TASMANIAN PLANNING COMMISSION

DECISION

Local Provisions Schedule Brighton

Date of decision 1 February 2021

Figure 1 Application of the Utilities Zone to land near the Bridgewater Bridge

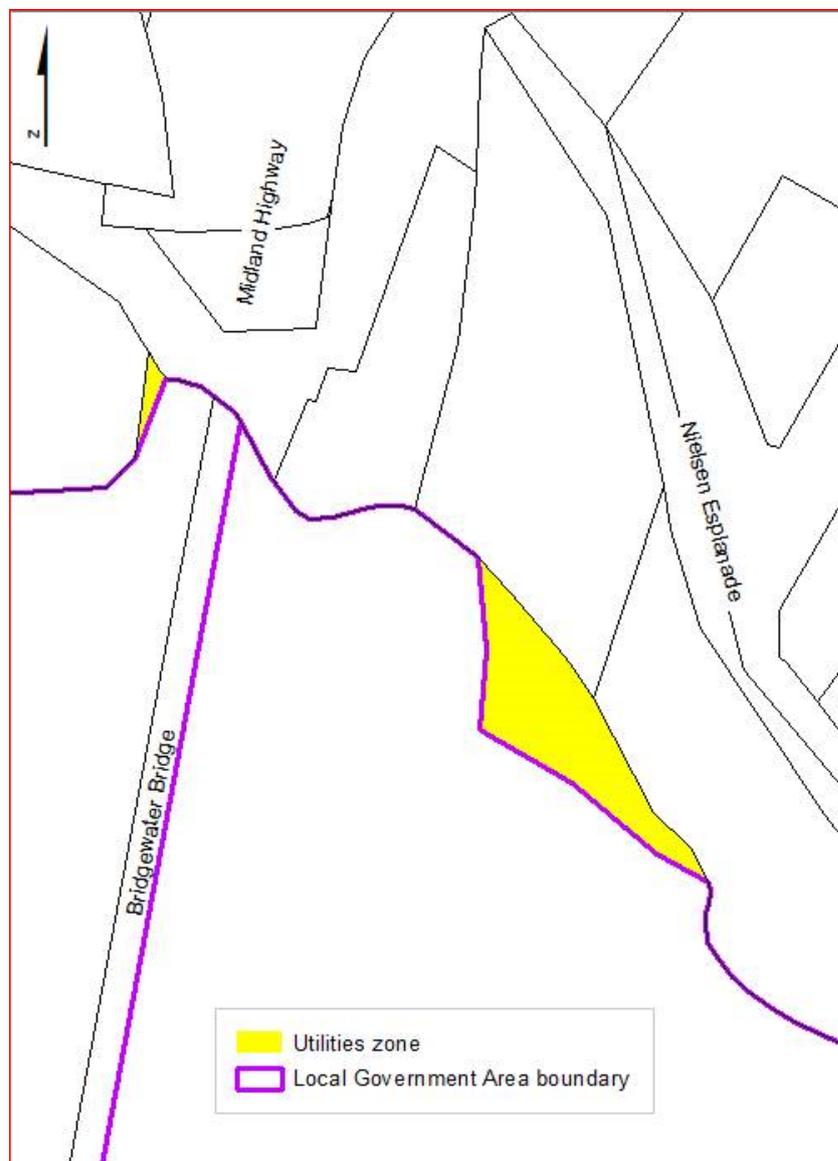
- Revise the zoning of 36 Old Main Road, Bridgewater to the Utilities Zone;
- Revise the zoning of 4 Nielsen Esplanade, Bridgewater to the Utilities Zone;
- Revise the zoning of two unreferenced small triangular areas of land on the river bank near the Bridgewater Bridge containing a small wharf (title to the west of the bridge) and a boat launching ramp and jetty (title to the east of the bridge) to the Utilities Zone as shown in Figure 1 below; and
- Revise the zone map to remove any zone shown outside the Brighton municipal area, as shown in Figure 1 below:
